SUBJECT: SURRY UNITS 1 AND 2 - ISSUANCE OF AMENDMENTS RE: SERVICE
WATER TEMPERATURE LIMIT (TAC NOS. M86944 AND M86945)

AMENDMENT NO. 183 TO FACILITY OPERATING LICENSE NO. DPR-32 - SURRY UNIT 1
AMENDMENT NO. 183 TO FACILITY OPERATING LICENSE NO. DPR-37 - SURRY UNIT 2

SAFETY EVALUATION BY THE OFFICE OF NUCLEAR REACTOR REGULATION
RELATED TO AMENDMENT NO. 183 TO FACILITY OPERATING LICENSE NO. DPR-32
AND AMENDMENT NO. 183 TO FACILITY OPERATING LICENSE NO. DPR-37
VIRGINIA ELECTRIC AND POWER COMPANY
SURRY POWER STATION, UNIT NOS. 1 AND 2
DOCKET NOS. 50-280 AND 50-281

**ALLOWABLE AIR PARTIAL PRESSURE
SURRY POWER STATION UNITS 1 AND 2**

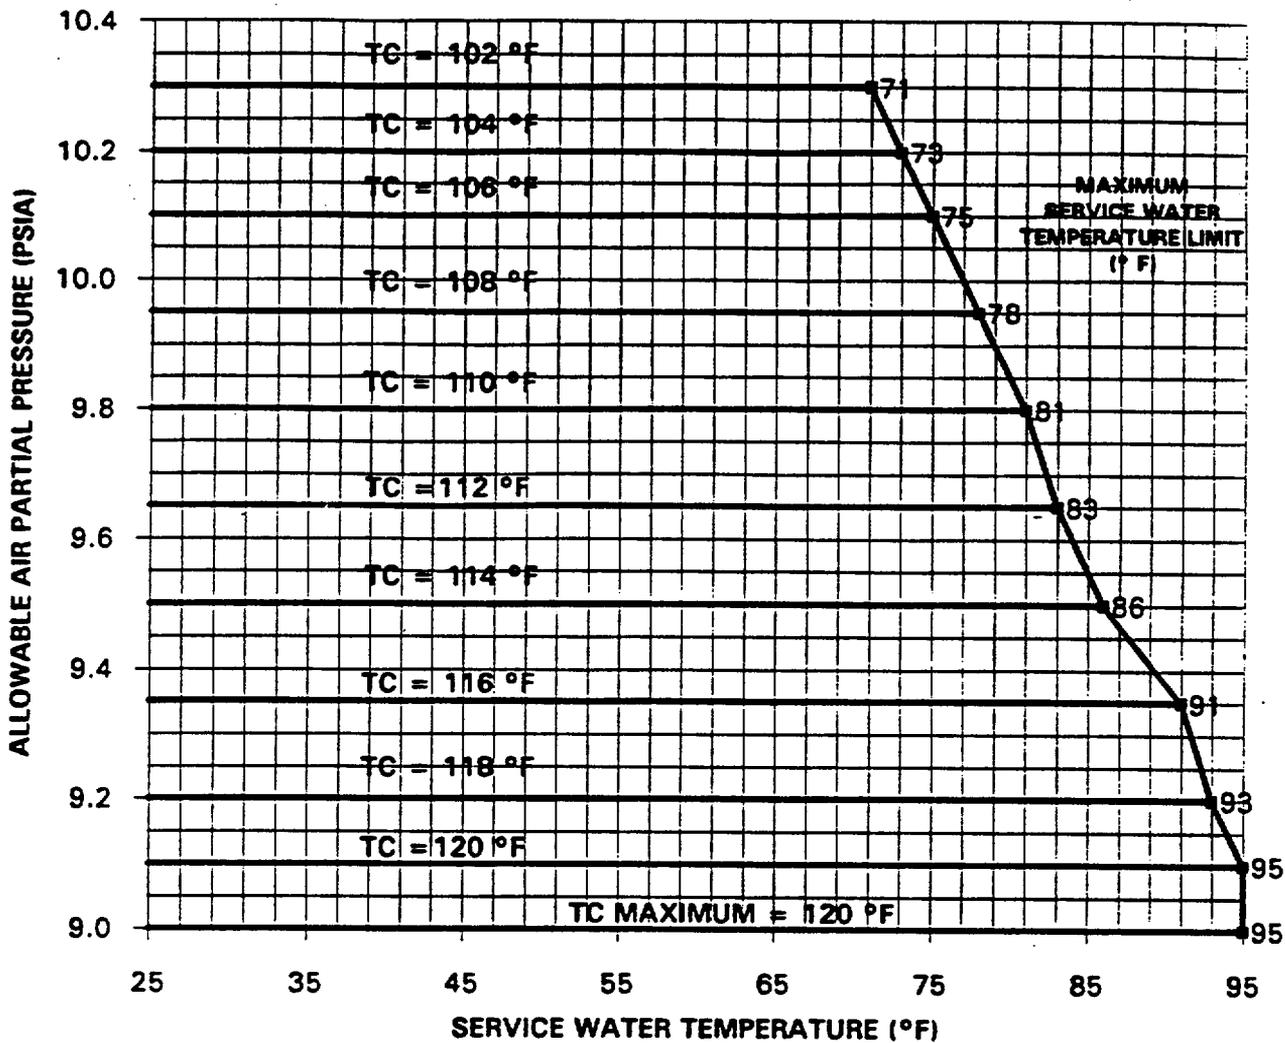
These amendments permit operation with a three degree increase in the service water temperature limit for containment air partial pressures of 9.1, 9.2 and 9.35 psia. Typographical errors made in previous amendments are also corrected.

TS Figure 3.8-1 is being revised to permit operation with a three degree increase in the service water temperature limit for containment air partial pressures of 9.1, 9.2, and 9.35 psia. The revised service water temperature limits for these partial pressures are 95°F, 93°F, and 91°F respectively. The curve on the figure is being revised to fit these points.

The licensee has performed containment response analysis at a three degree higher service water temperature for containment air partial pressures of 9.1, 9.2, and 9.35 psia. Models, methods, and input consistent with the current analysis of record were used for the analysis. The licensee used previously existing analysis margins to accommodate the impact of the three degree service water temperature shift. The results of the analysis indicate that the worst case values for the post loss-of-coolant accident containment response criteria are still bounded by the safety analysis. The response criteria are peak pressure, depressurization time, subatmospheric peak pressure and engineered safety features pump net positive suction head.

Since the analysis indicates that the containment will continue to meet its design basis acceptance criteria following a DBA, and since the analysis was performed with current models, methods and inputs, the staff finds the licensee's proposed revision to TS 3.8 acceptable.
